Re: In the Matter of PORTLAND GENERAL ELECTRIC COMPANY,  
Draft Storage Potential Evaluation  
**Docket Nos. UM 1856**

**UM 1856**

**OPENING TESTIMONY OF DR. BENJAMIN FITCH-FLEISCHMANN**

12 *Figure 1 - Indicative Pricing for 20 MW / 80 MWh*

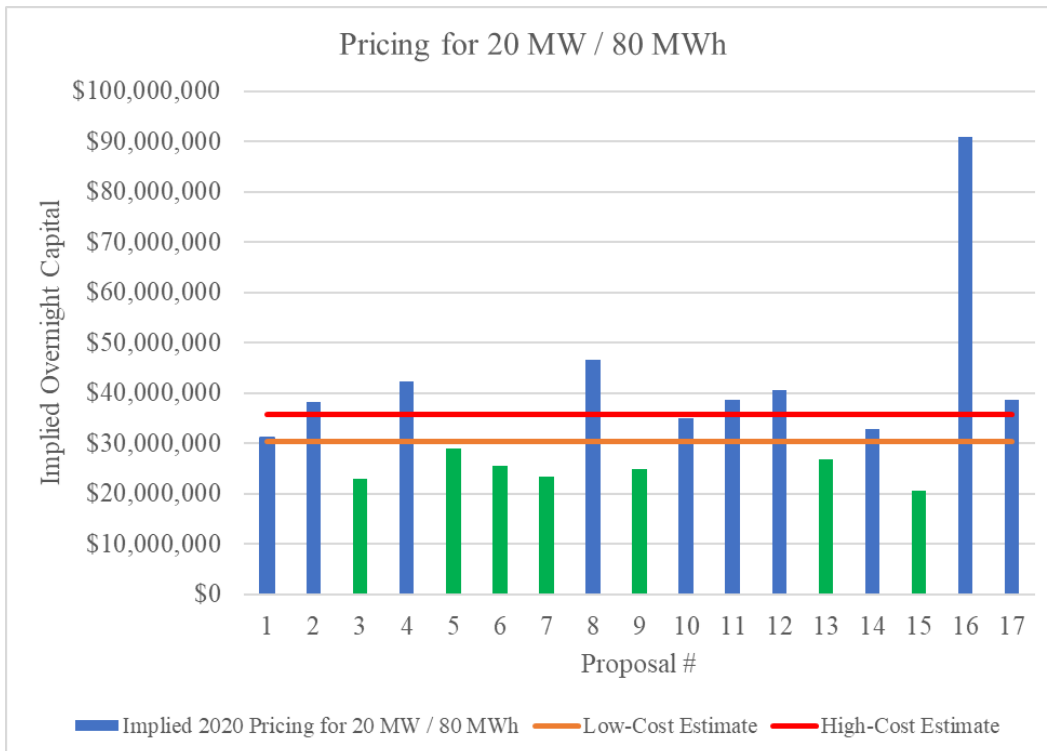
5 A Energy storage has experienced tremendous price reductions in the last five years. For  
6 instance, lithium ion batteries in 2013 cost \$800 per megawatt hour (“MWh”), today the  
7 cost is \$275/MWh. Two years ago inverters were \$0.15 per watt (“W”), today tier 1  
8 inverters cost \$0.08/W. Figure 1 shows the implied cost of a 20 MW / 80 MWh system  
9 using 17 different proposals from RFPs managed by Fractal. It is important to note that  
10 almost half of the costs are lower than PGE’s “Low-Cost Estimate” for its Coffee Creek  
11 pilot.<sup>4</sup>

Figure 2 - Results of 10 MW / 10 MWh RFP Managed by Fractal

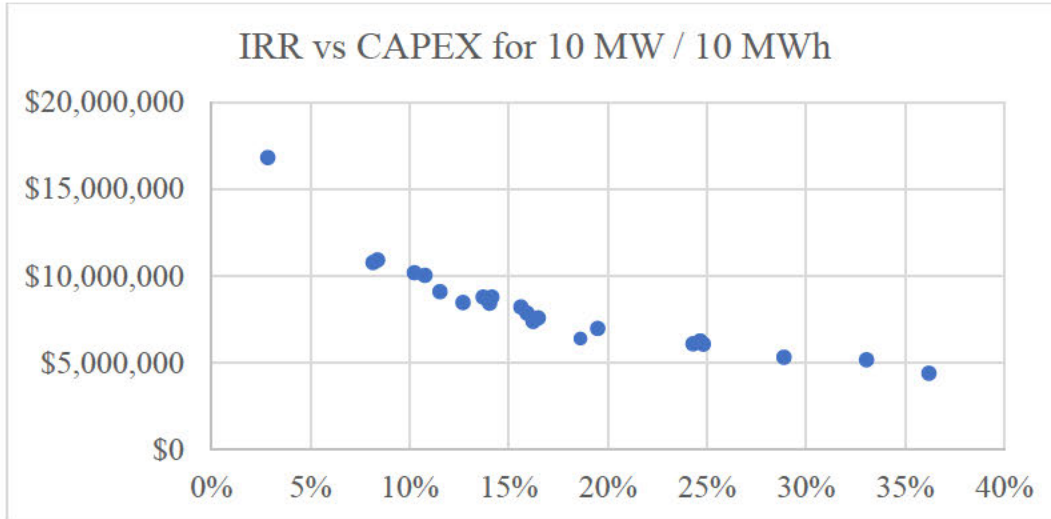
12 To illustrate the impact overnight capital costs have on a storage project, Figure 2  
 13 shows internal rate of return for a similar sized project. PGE’s “Low-Cost Estimate” is  
 14 15% higher than Fractal’s estimate, as a result the higher cost would significantly reduce  
 15 net benefits to PGE customers.  
 16

Figure 3 - Annual O&M Expenses from a Fractal Managed RFP

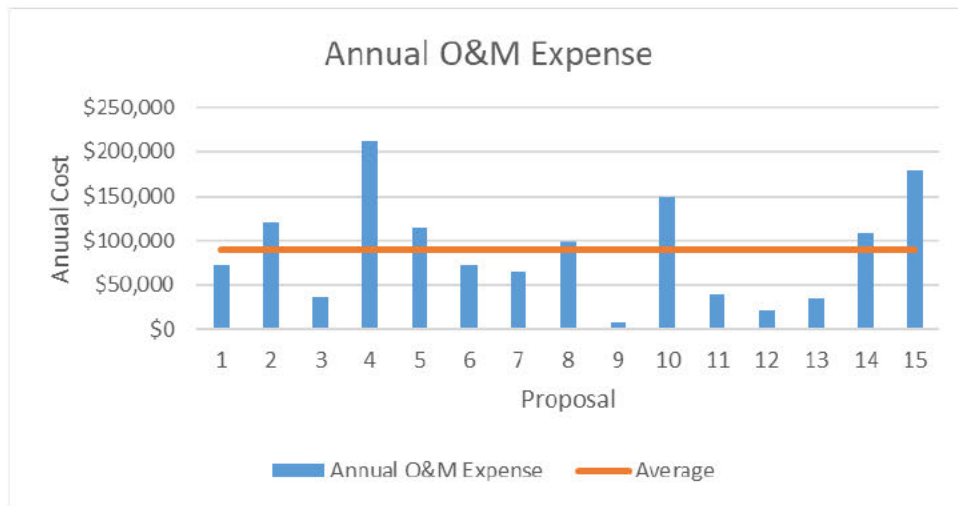
**A** In our experience in operating storage and managing procurements, we have found that OPEX is considerably less than the PGE estimates. For example, in a 10 MW / 10 MWh (1-hr) energy storage project, the average operations and maintenance (“O&M”) cost was approximately \$90,000 per year (see Figure 3).

4  
5 *Figure 4 - Site Layout for 20 MW / 80 MWh*

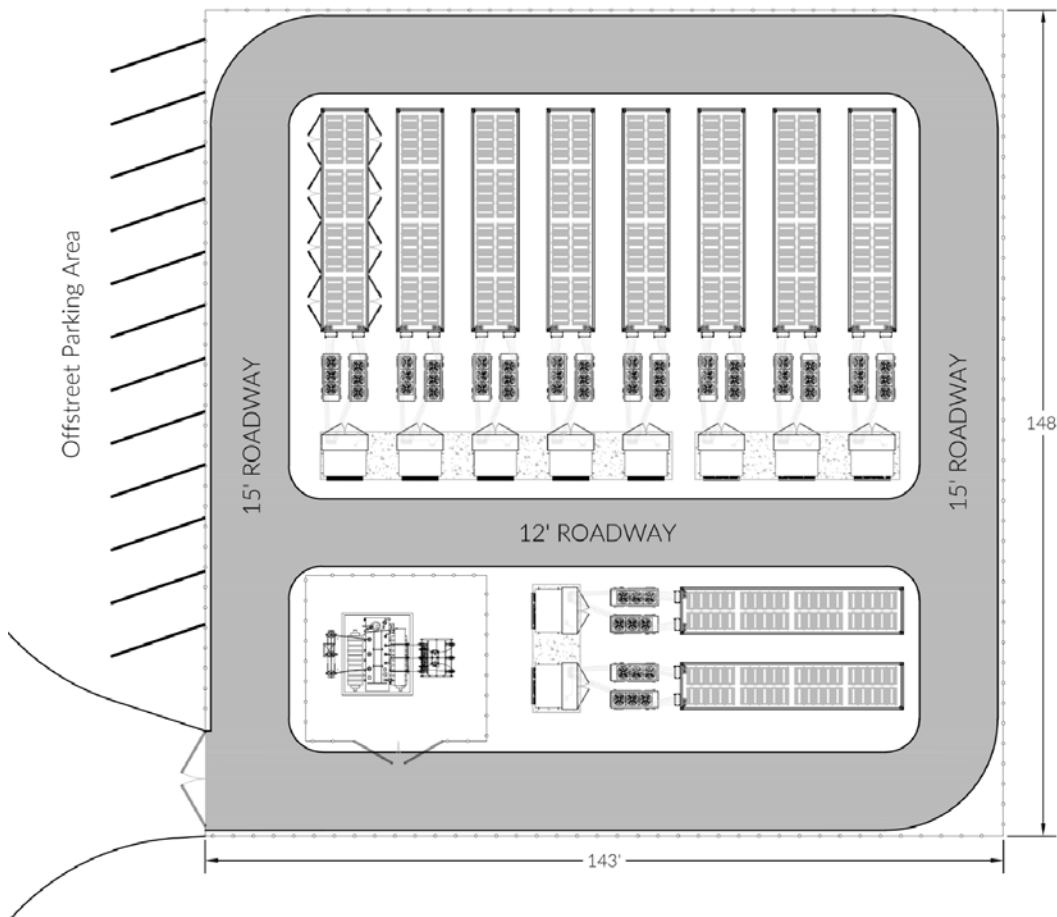
Figure 4 shows the footprint of a generic 20 MW / 80 MWh project, which is roughly equal in size to PGE’s Coffee Creek project. This generic project would require

1 approximately ½ acres for equipment and ½ acres for parking, access and setbacks.  
2 Assuming an annual lease rate of \$1.50/sf, the land costs for storage are relatively small  
3 (\$65,340/yr).
